March 30, 2009

36 C.F.R. 215 APPEALS

APPEAL OF JACOB RYAN VEGETATION MANAGEMENT PROJECT

TITLE OF DECISION DOCUMENT: Decision Notice and Finding of No Significant Impact for the Jacob Ryan Vegetation Management Project.

Figure 7. Existing condition of canopy cover in the even-aged stands in Jacob-Ryan.

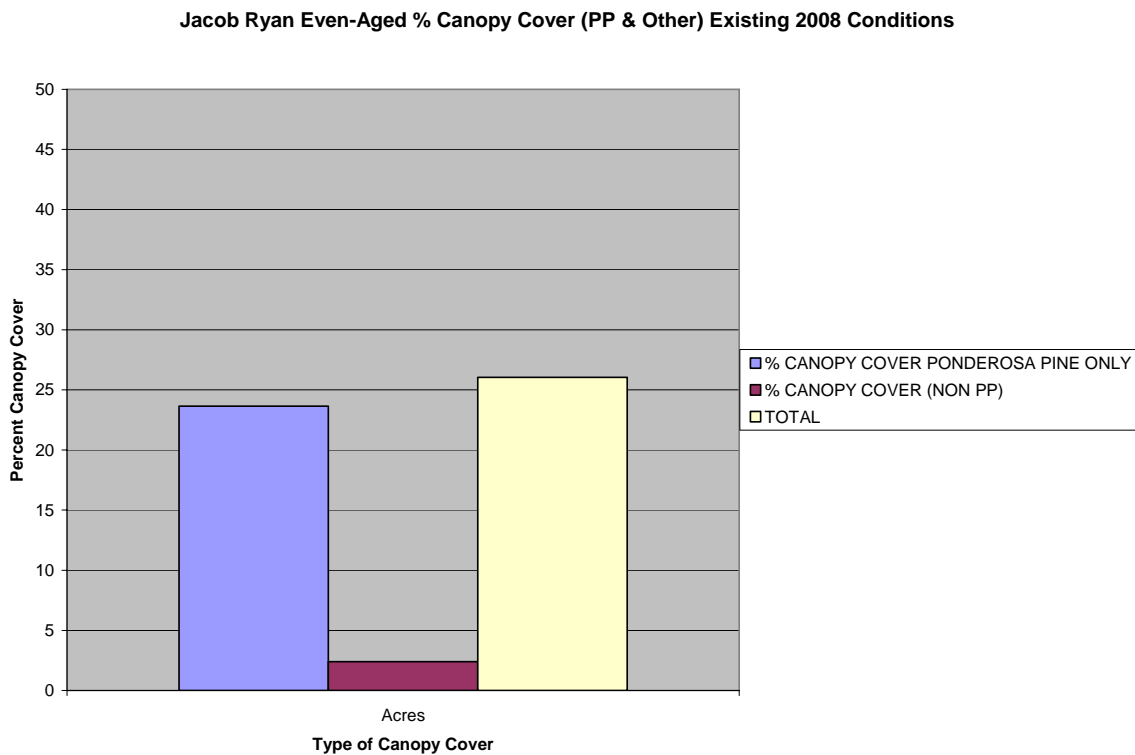
Evidence in the project record suggests that the Jacob Ryan Project will not meet KNF Plan standards and guidelines for canopy cover in older VSS classes. First, even-aged stands created by past “shelterwood” logging, which comprise approximately 25 percent of the project area (EA at 30), are severely deficient in canopy cover now. Figure 7 (below – see Vegetation

Report (“VR”) at 14) shows that canopy cover in even-aged ponderosa pine stands averages less than 25 percent now. Indeed, the Forest Service admits that it cannot meet KNF Plan standards for canopy cover in older VSS classes in even-aged stands:

Figure 20. Canopy cover for uneven-aged strata in 2008 showing existing conditions.

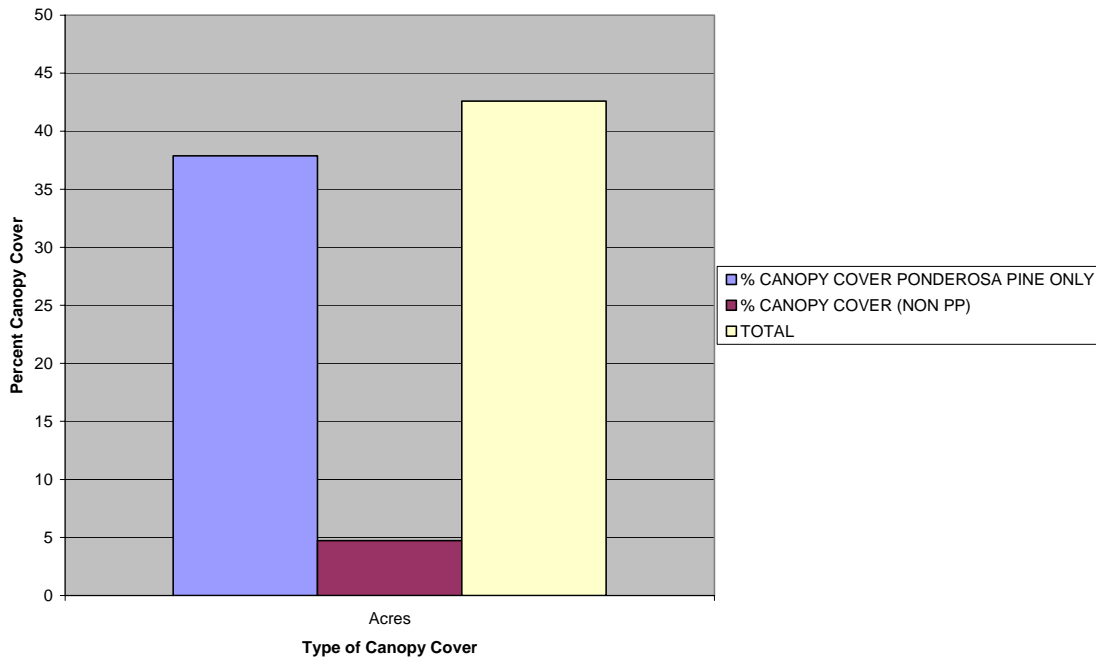
VR at 20. Figure 20 (below – VR at 29) corroborates Table 14 (above), and the Vegetation Report further states, “Given greater density in the nest areas, the overall coverage in ponderosa pine is approximately 37% over the entire uneven-aged area ...” VR at 29. Nest areas contain only VSS 5 and 6 classes with canopy cover ranging from 50-70%. *See* KNF Plan at 30. It is unclear from the record to what degree VSS 4 classes contribute (or not) to overall canopy cover in the uneven-aged ponderosa pine strata. The EA contains no analysis correlating existing or desired SDI values in any strata with canopy cover (per the KNF I&I Appendix B), let alone what the proposed action would do. The EA never quantifies existing canopy cover or effects of the proposed action. However, Table S2 (below) evidences that uneven-aged stands in the project area average 23% canopy cover now. *See* EA at 114. Synthesizing the available data, it appears (though the Forest Service does not disclose) that canopy cover in uneven-aged VSS 4 is incredibly low. Therefore, any removal of trees with crown characteristics that contribute to canopy cover in VSS 4 classes probably violates the KNF Plan and NFMA.

Figure 1. Tree size class distribution in southwestern ponderosa pine forests. Source: USDA (1999, 2007a).

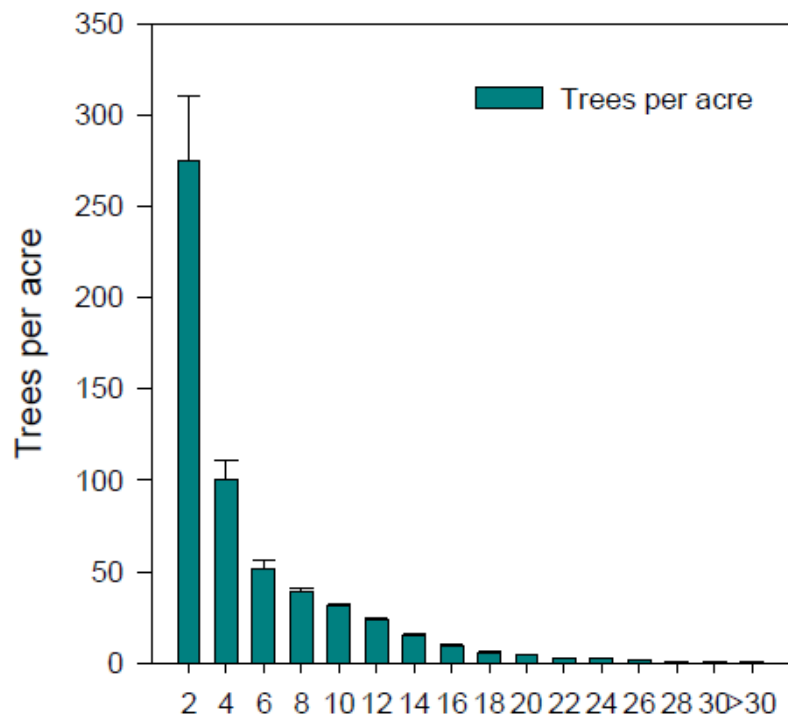
Moreover, Forest Service data do not support the agency’s stated reasons for resisting a 16” diameter limit on tree cutting in uneven-aged strata of the Jacob Ryan Project. It states regarding Alternative 3 (12” limit),

Figure 11. Trees per acre by VSS class for No Action, existing and desired condition, in 2008.

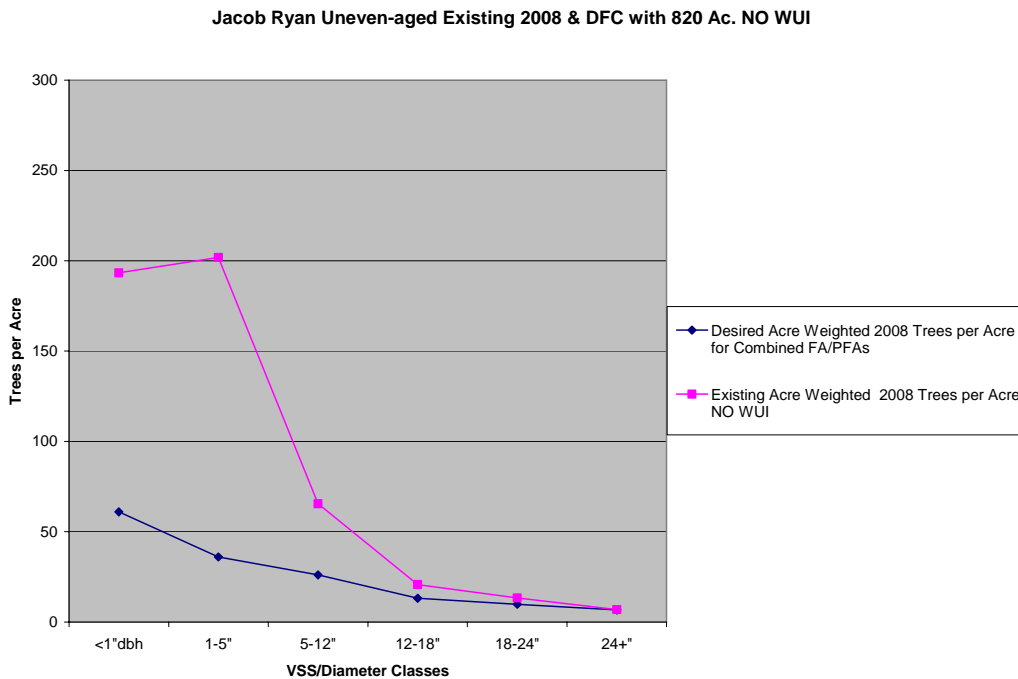
VR at 21. It is clear from Forest Service data that excessive tree densities diminish near 10” dbh and level off at 16” dbh under current conditions. Additionally, Figure 12 shows that limiting logging to trees <16” dbh will have no impact on uneven-aged stand density 45 years from now.

Figure 12. Trees per acre by VSS class for No Action, existing and desired condition, in 2053.

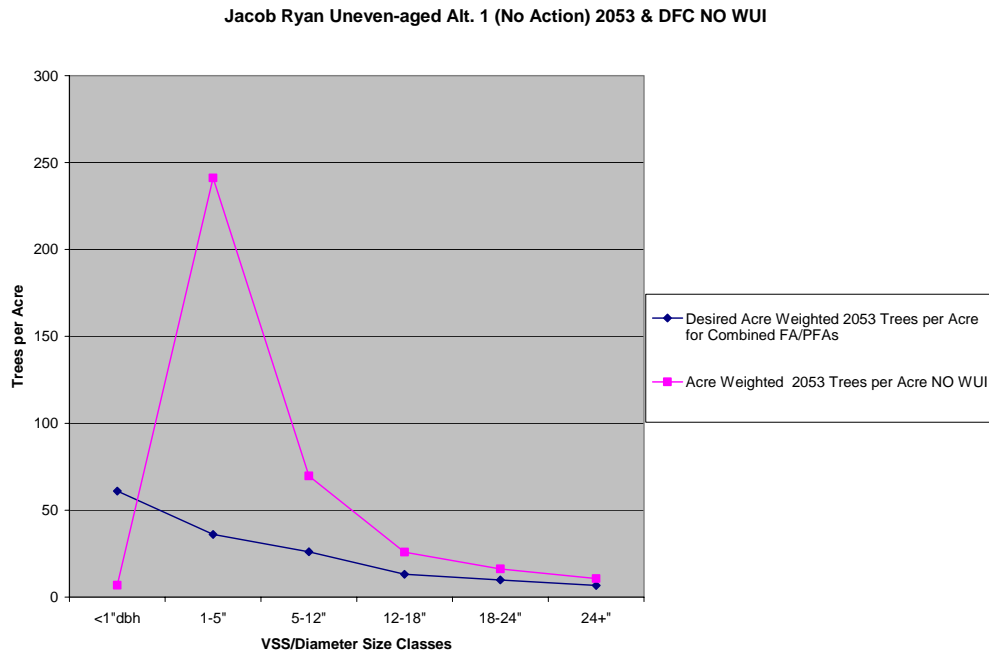
VR at 22. In the modeled projection of the no-action alternative, tree densities spike above current conditions in the VSS 2 class and remain elevated in VSS 3, but remain almost the same, again within the undefined margin of error, in VSS 4 and larger size classes.
